SUBDIVISION COMMITTEE
METROPOLITAN AREA PLANNING
COMMISSION

STAFF REPORT
(Preliminary Plat)

CASE NUMBER: S/D 87-100 - LAGALY THIRD ADDITION

VICINITY MAP:

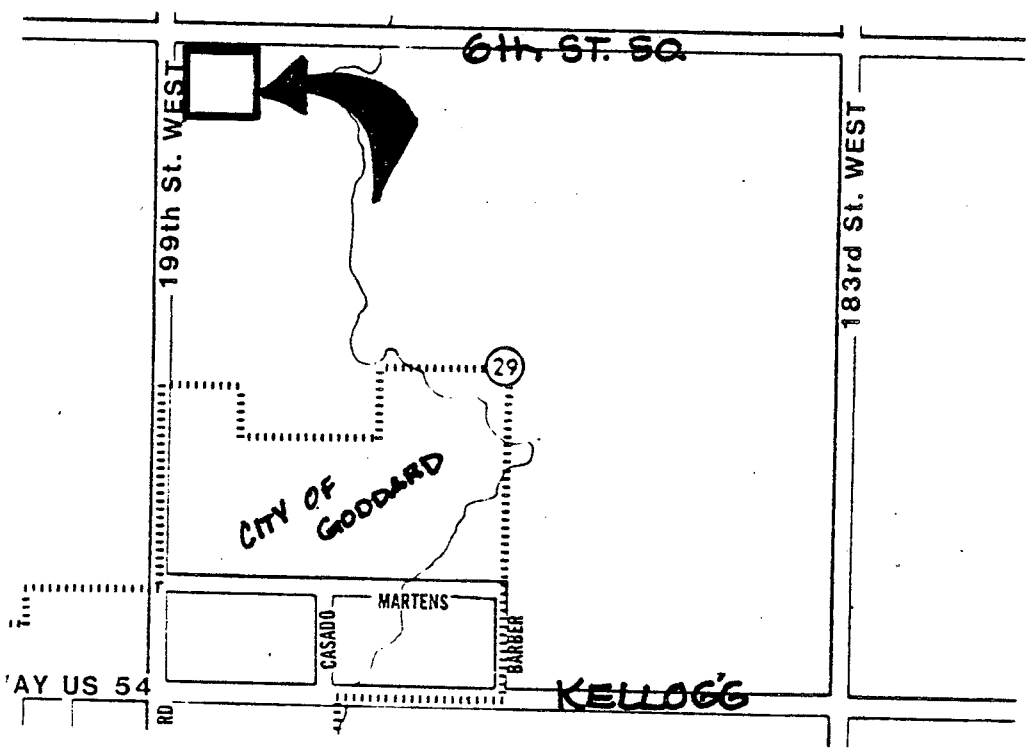
- A. Since neither municipal water nor sanitary sewer is available to serve this property, the applicant shall contact the Environmental Health Division of the Health Department to find out what tests may be necessary and what standards are to be met for approval of on-site sewerage facilities and water wells. A memorandum shall be obtained specifying approval.

- B. In accordance with Section 7-201(H) of the Subdivision Regulations, the final plat shall indicate the 75 feet of half-street right-of-way required at the intersection of arterial streets. Since both 199th Street West and 6th Street South are section line roads, they are also considered to be arterial streets.

- C. After dedicating the required rights-of-way for the adjacent section line roads, Lot 1 will contain approximately .36 acres and Lot 2 will contain 4.4 acres. If the Health Department is unable to approve septic tank systems for the two lots, due to unsuitable soils, a problem will exist in that neither lot will contain the needed 5 acres required for an on-site sewage lagoon. If this problem materializes, the final plat shall indicate an adjustment of the plat's perimeter so as to provide a minimum lot area of 5 acres, exclusive of land being dedicated for street right-of-way. The prohibition of including street right-of-way as part of a lot's area, is clearly stated in Section 7-204(F) of the Subdivision Regulations. As can be noted from the preliminary plat, the applicant owns the property to the south of this subdivision.

- D. The applicant shall guarantee any drainage improvements required by the platting of this property.
 - E. On the final plat, the centerline of the 20-foot utility easement, centered on the lot line common to Lots 1 and 2, shall be labeled.

- F. On the final plat, "complete access control" shall be indicated to 199th Street West from the north 40 feet of Lot 1 and "complete access control" shall be indicated to 6th Street North from the west 40 feet of Lot 1.

- G. The final plat shall indicate the drainage easement or floodway reserve needed on this property. If a floodway reserve is indicated, the standard floodway language shall be included as a part of the plat's text.

- H. The final plat shall indicate the existing Southwestern Bell easement existing adjacent to the west line of the plat. The recording information for this existing easement shall be referenced.

VICINITY MAP:

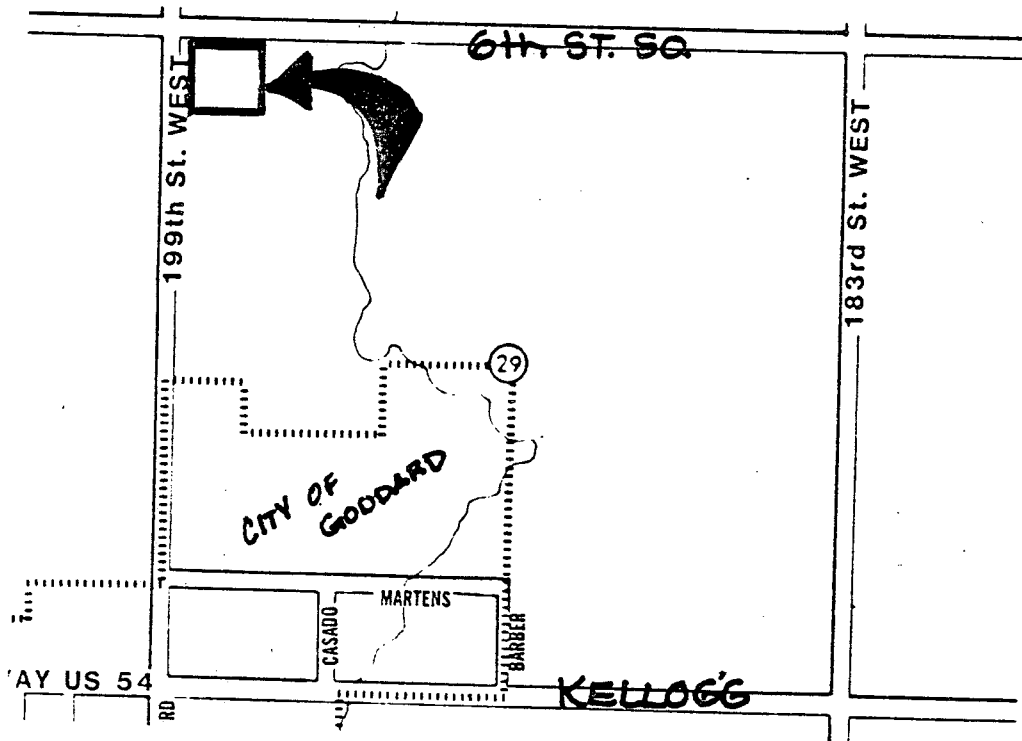
- A. Since neither municipal water nor sanitary sewer is available to serve this property, the applicant shall contact the Environmental Health Division of the Health Department to find out what tests may be necessary and what standards are to be met for approval of on-site sewerage facilities and water wells. A memorandum shall be obtained specifying approval.

- B. In accordance with Section 7-201(H) of the Subdivision Regulations, the final plat shall indicate the 75 feet of half-street right-of-way required at the intersection of arterial streets. Since both 199th Street West and 6th Street South are section line roads, they are also considered to be arterial streets.

- C. After dedicating the required rights-of-way for the adjacent section line roads, Lot 1 will contain approximately 3.6 acres and Lot 2 will contain 4.4 acres. If the Health Department is unable to approve septic tank systems for the two lots, due to unsuitable soils, a problem will exist in that neither lot will contain the needed 5 acres required for an on-site sewage lagoon. If this problem materializes, the final plat shall indicate an adjustment of the plat's perimeter so as to provide a minimum lot area of 5 acres, exclusive of land being dedicated for street right-of-way. The prohibition of including street right-of-way as part of a lot's area, is clearly stated in Section 7-204(F) of the Subdivision Regulations. As can be noted from the preliminary plat, the applicant owns the property to the south of this subdivision.

- D. The applicant shall guarantee any drainage improvements required by the platting of this property.
- E. On the final plat, the centerline of the 20-foot utility easement, centered on the lot line common to Lots 1 and 2, shall be labeled.

- F. On the final plat, "complete access control" shall be indicated to 199th Street West from the north 40 feet of Lot 1 and "complete access control" shall be indicated to 6th Street North from the west 40 feet of Lot 1.

- G. Prior to, or at the time of submitting the final plat, the applicant shall submit a drainage plan to County Engineering for review and approval.
- H. The applicant's engineer is advised that the Register of Deeds is requiring the name(s) of the notary public, who acknowledges the signatures on this plat, to be printed beneath the notary's signature.

- J. Requirements for a final plat (see pages 20-25, Part 4, Article 5 of the MAPC Subdivision Regulations).
- K. The representative from County Engineering should be prepared to comment on the status of the applicant's drainage concept.

VICINITY MAP:

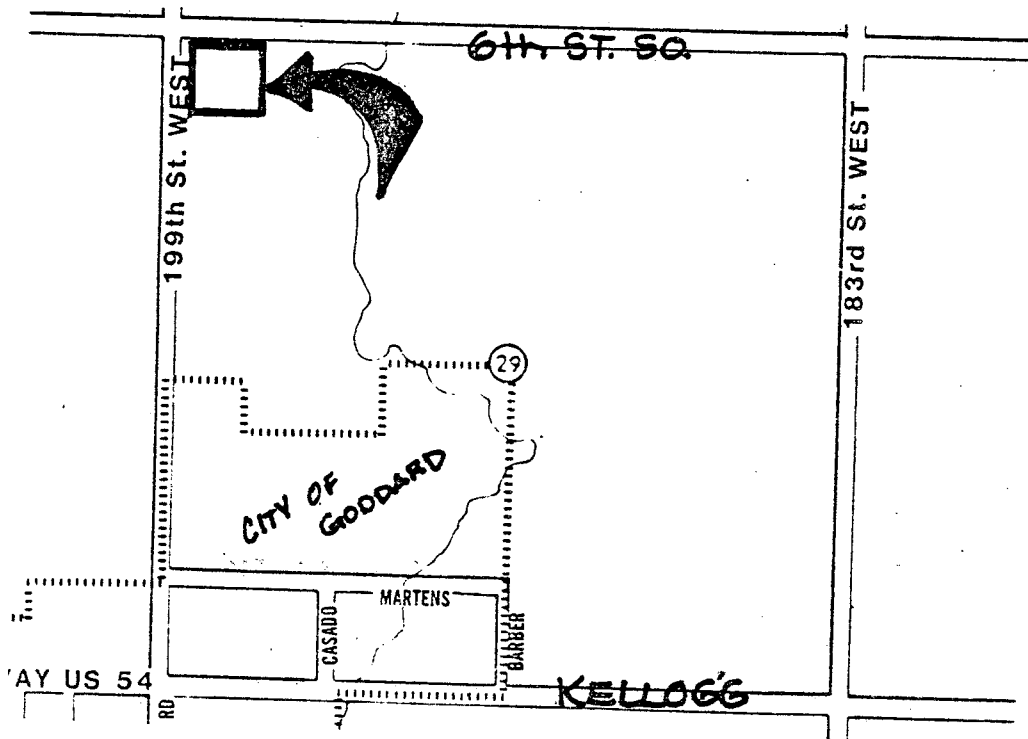
- A. The Health Department has advised that the soils on this site are appropriate for the construction and operation of a sewage lagoon. Additionally, the Health Department is recommending a variance of the minimum 5-acre lot size for lagoons. This variance is being granted on a one-time only basis. The variance is needed because both proposed lots have been prematurely sold to new owners and the obtaining of additional usable land is doubtful because of the drainage characteristics of the plat and surrounding areas.

- B. The applicant shall guarantee any drainage improvements required by the platting of this property.
- C. The platting text shall be amended to state that the access controls are being dedicated to the appropriate governing body.

- D. On the final plat tracing, the appropriate year (1988) should be inserted where necessary.
- E. The applicant shall install or guarantee the installation of all utilities and facilities which are applicable and described in Article 8 of the MAPC Subdivision Regulations.

- G. Perimeter closure computations shall be submitted with the final plat tracing. Section 5-101(C).
- H. Recording of the plat within 30 days after approval by the City Council.

- I. The representative from County Engineering should be prepared to comment on the status of the applicant's drainage plan.
